Town of Clinton Land Use Board

The Environmental Commission of the Town of Clinton (EC) has reviewed the project summary, colored rendering of the site plan, and traffic impact study for the redevelopment of the former A&P property on 49 NJSH Route 173 (Block 21, Lots 29, 30.01, 31, 32 and 33) in the Town of Clinton prepared by Old 22 Urban Renewal Associates, LLC. The following comments and questions are of high interest to the EC and the EC would like them to be considered and/or responded to by the Applicant during their planned testimony to The Town of Clinton Land Use Board (Board) in October 2020:

Examples of Acceptable / Unacceptable Lighting Fixtures

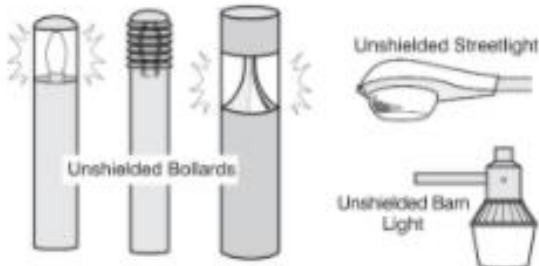
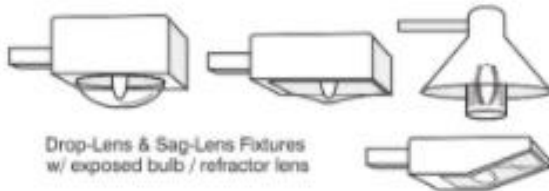
- 5. Lighting** – Describe the plan for exterior lighting. It should only be used where needed and be no brighter than necessary. Consider using motion-detection lighting where possible. Minimize blue light emissions. All lighting should be fully shielded with no upward pointing fixtures (see illustration below). Any decorative landscape lighting should be turned off by 11 PM. Particular sensitivity should be placed on the area between the development and Center Street properties.
